ONE-STEP FINAL PLAT
AUBURN HILLS 3RD ADDITION
WICHITA, SEDGWICK COUNTY, KANSAS

Re: S/D 96-83 - AUBURN HILLS 3RD ADDITION (Final Plat)

Re: S/D 96-83 AUBURN HILLS 3RD ADDITION (Final Plat)

CASE NUMBER: S/D 96-83 - AUBURN HILLS 3RD ADDITION

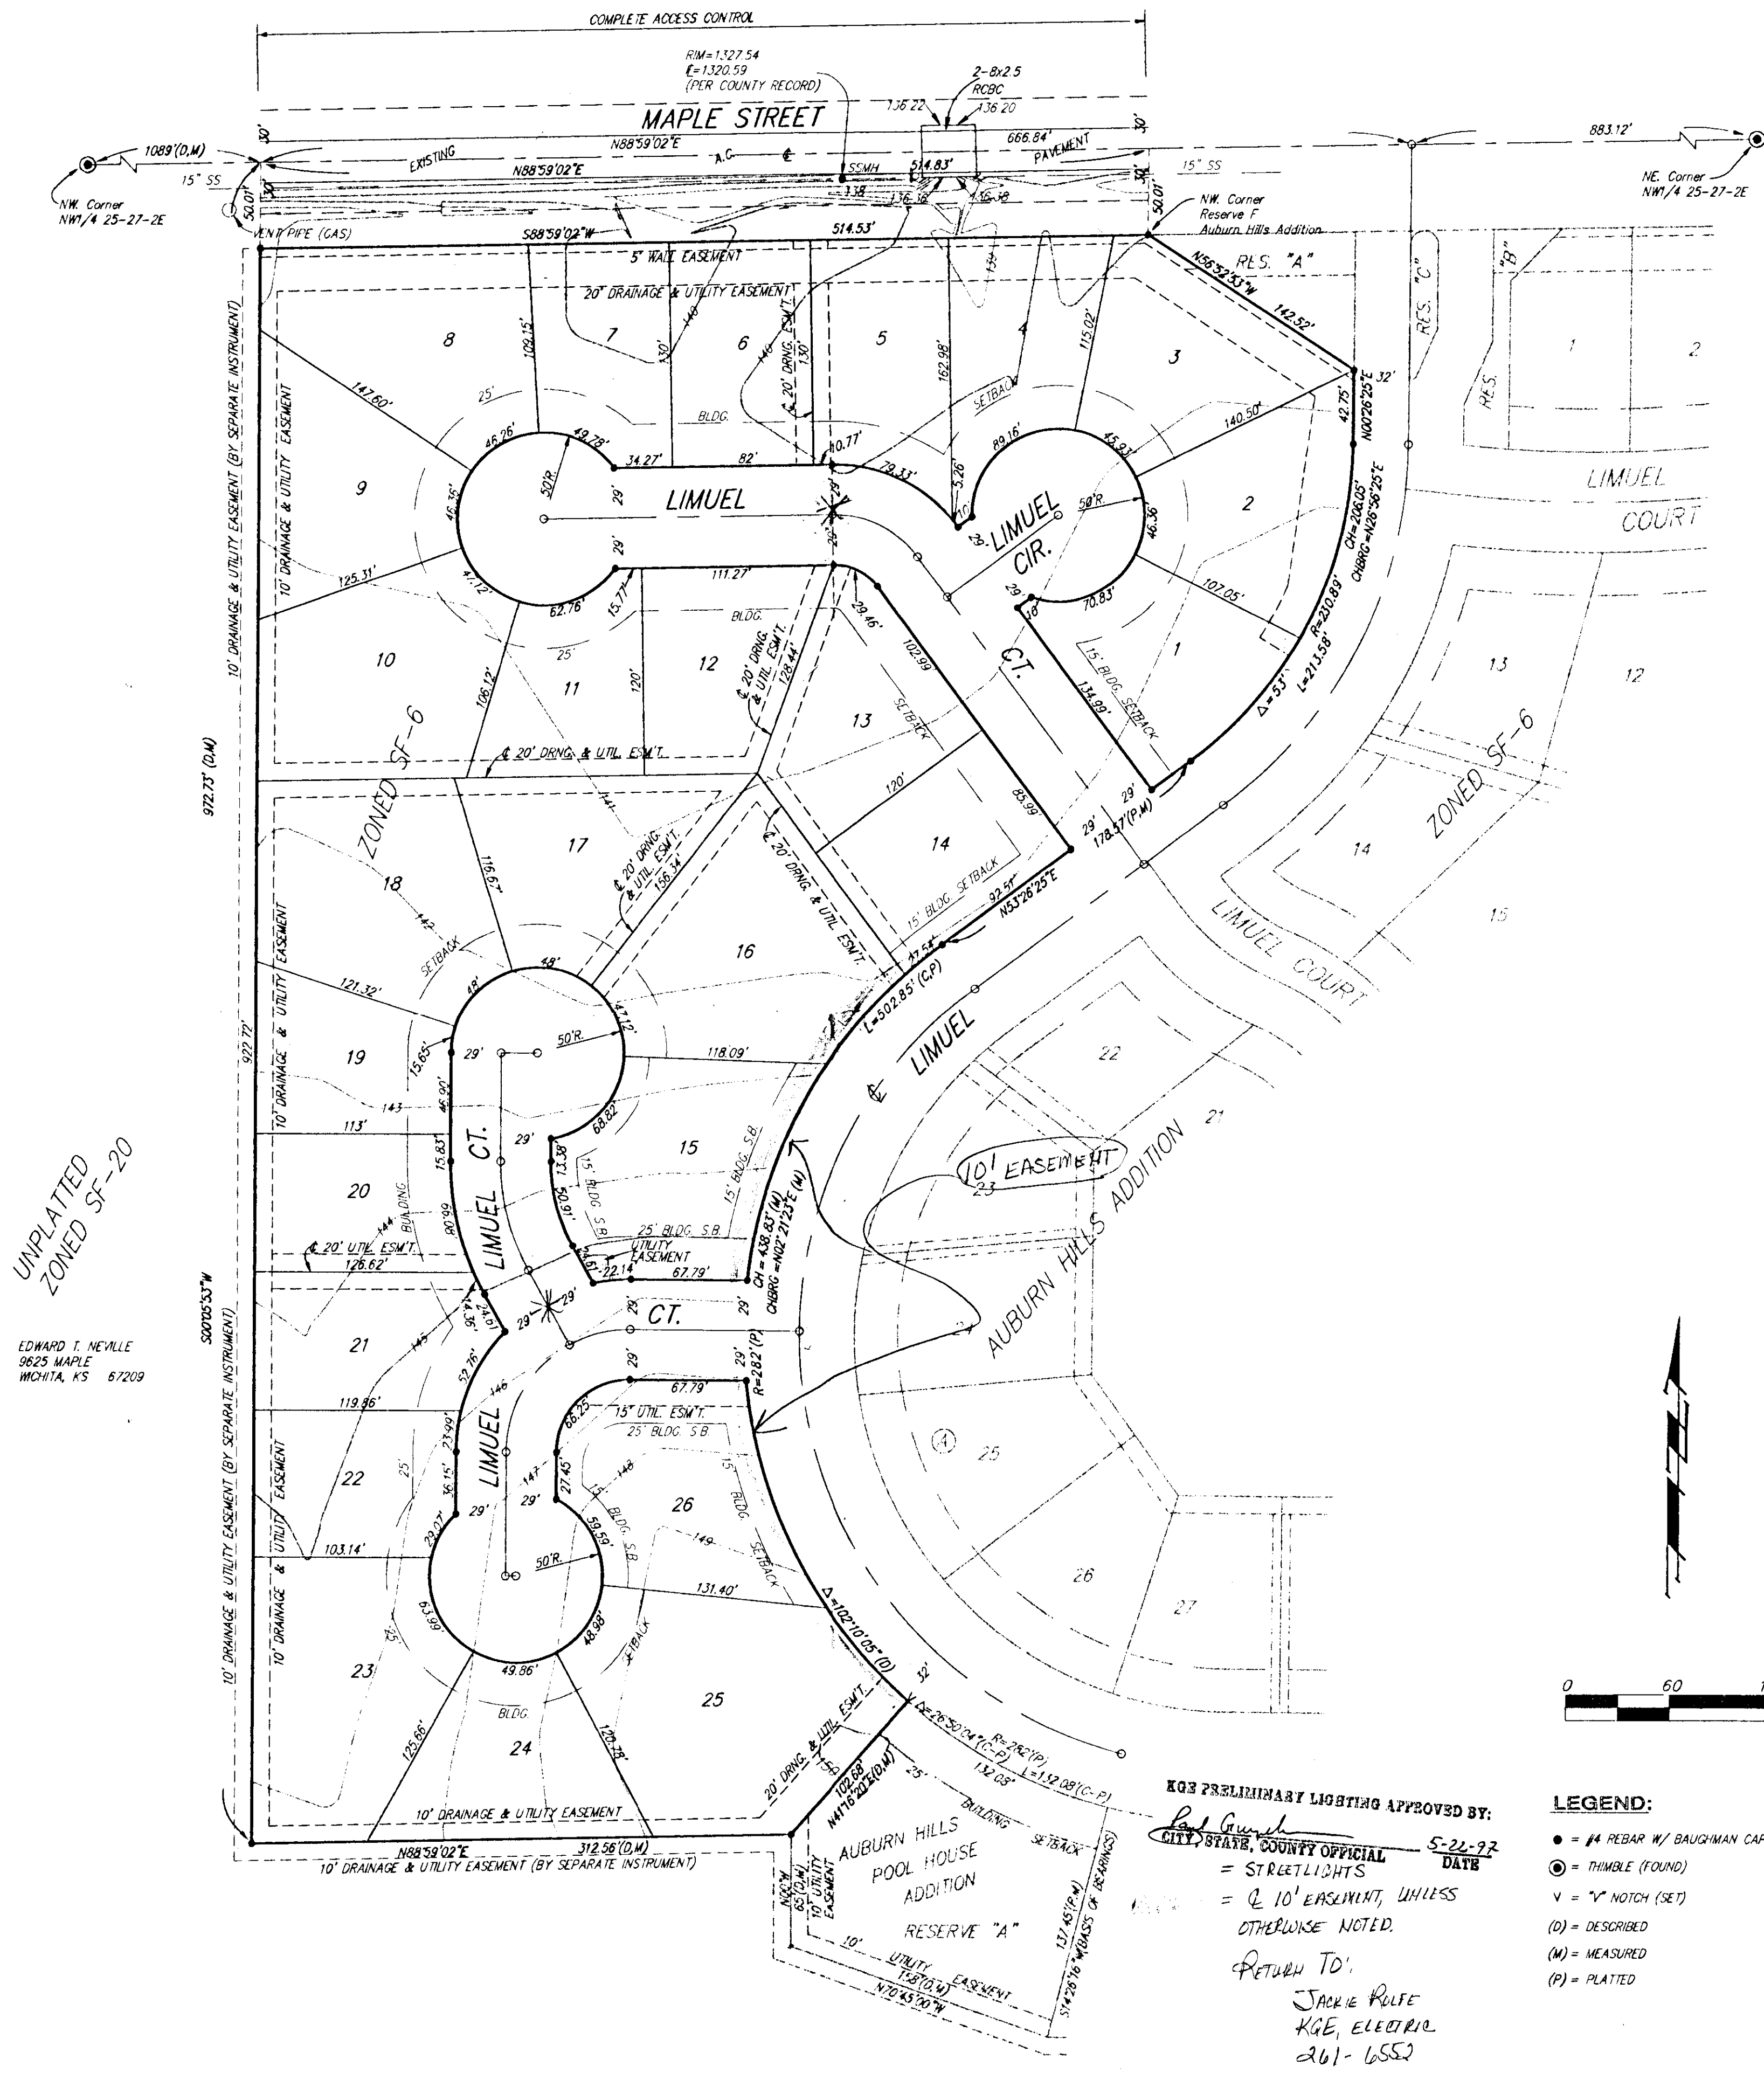
- H. On the final plat tracing, complete access control shall be shown to Maple from all abutting lots.

- R. The final plat tracing shall indicate the utility easements requested by K.G. & E. which are indicated on the enclosed "marked" copy of the plat.
- S. On the Final Plat Tracing, right-of-way for Maple shall be provided for 50-feet of 1/2 street right-of-way from this site. It appears that the 40-feet shown is not accurate and that 50-feet is the actual dimension. In any case, 50-feet shall be dedicated and properly shown.

- T. On the final plat tracing, the center line ("CL") of Maple shall be labeled.
- U. On the final plat tracing, the following amendments shall be made to the platfor's text.

5. Both the face of the plat and platfor's text has deleted reference to a wall easement along the site's north line. If a wall is still intended, both the face of the plat and platfor's text will need to indicate this. In regard to the 20-foot easement now being shown, any 5-foot wall easement would need to be platted exclusive of any other such easements (utility, drainage, etc.). That is a 20-foot utility/drainage easement, with an adjacent 5 ft. wall easement would need to both be shown.

- V. Since this is a plat of unplatted property, the reference to K.S.A. 12-512(b) in the Surveyor's text is generally not appropriate unless public reservations by separate instruments are involved. However, the platting indicates that no separate instruments are involved on this site.

- W. In regard to W. Kent, the prefix "W" does not appear to be appropriate. Kent exists to the east of this site (1/2 mile) but is only found in this area. That is, there is no "E" side Kent and the use of "W" Kent may imply a new, different Street. The "W" therefore shall be deleted. Also, the "eyebrow" court coming off of Kent as shown is not a circle, and if distinctly named, should be labeled as a Court (a Kent Ct.)

- Y. Also, the plat binder indicates that the State Bank of Colwich holds a mortgage on this site. This party shall therefore be shown on the plat as a signatory.
- Z. On the final plat tracing, "Deputy" shall be deleted from the City Clerk's signature block.
- AA. On the final plat tracing, additional information shall be shown for street right-of-way. Both the width of Limuel Court along the spine of this street and the radius of the turnaround need to be shown.

For Kent, additional street right-of-way dimensions need to be shown for this street's entrance from Limuel and for the Court area that surrounds Reserve "D". If necessary, separate distinct drawings of these areas may need to be added to the final plat tracing.

- BB. On the final plat tracing, the indicated tiepoint to the N.E. corner of the N.W. 1/4 (quarter) needs to reference range 2W not 2E.
- CC. Also, the tying of this site to a Reserve in the Auburn Hills (1st) Addition, at the northeast corner of this plat, should correct the involved Reserve as being Reserve "A" not "F".

- DD. On the final plat tracing, appropriate dimensions shall be shown for the building setbacks of corner lots. Specifically, Lots 20 and 25, Block 1, shall indicate a 15-foot building setback to Limuel. Lot 1, Block 2 also needs to indicate additional dimensions to better describe the setback being shown to Limuel.
